MODIFICATION RECOMMENDED

MSO9104A-01

S E R V I C E N O T E

MSO9104A 1GHz Mixed Signal Oscilloscope

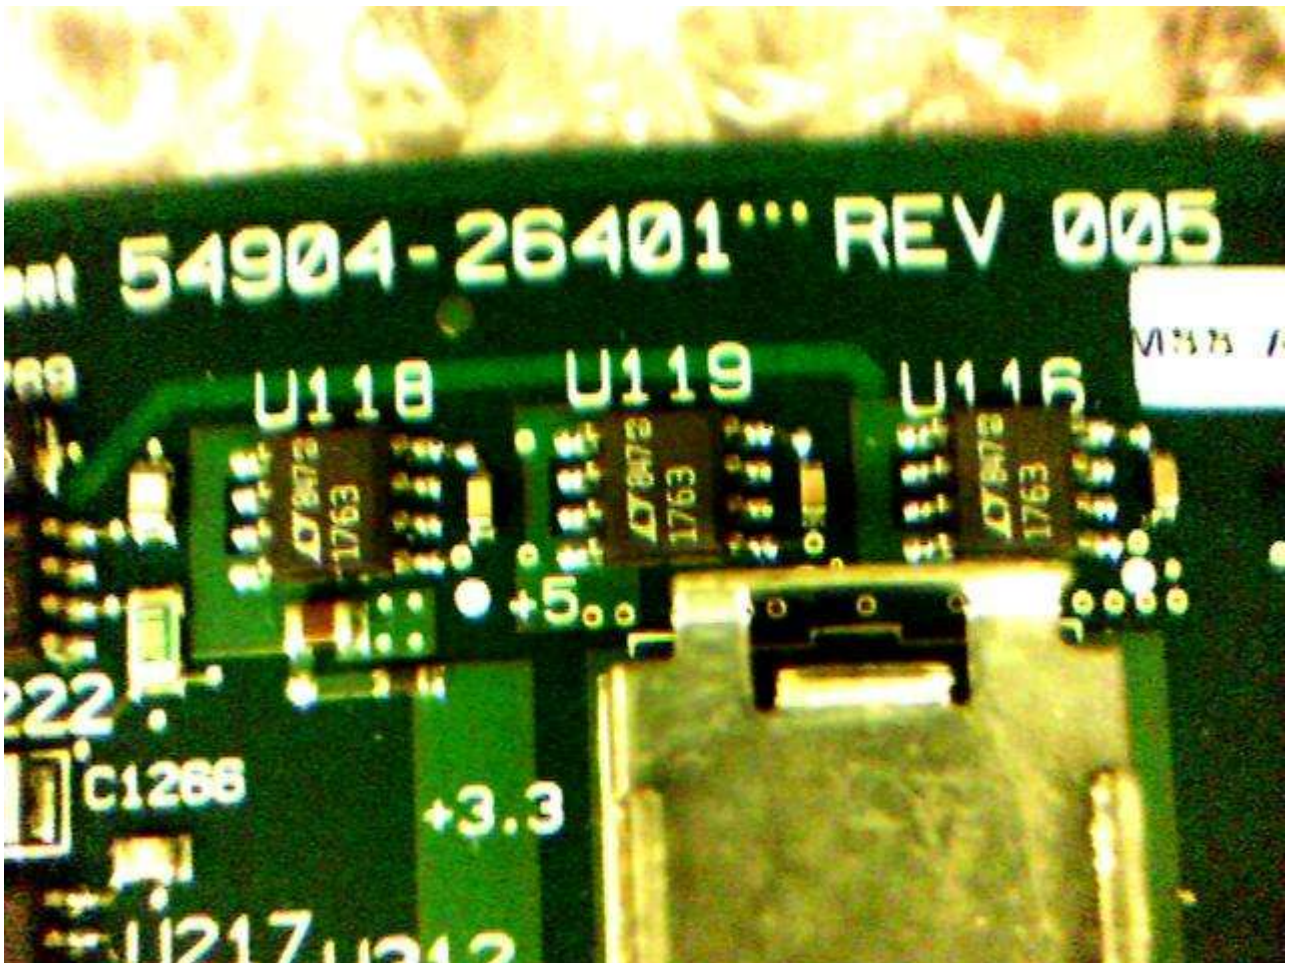
This is a onetime replacement because you are replacing the acquisition board 54901-66501 rev 005 with a later board rev of at least 006. The below picture shows a typical board number with the board rev listed. The board number 5490X-26401 is the raw PC board number. Once the board is loaded with parts and tested, the board number changes to 5490X-66501. The important part of the below picture is that the board rev of 005 is shown. This board must be removed from the scope and returned to SPO. SPO will return the defective board to AMC. You can install a new or refurbished acquisition board in the scope. At the writing of this service note, the new board part number was 54901-66501 and the refurbished part number was 54901-69501. If the board rev is 006 or higher, do not replace the acquisition board with this service note.
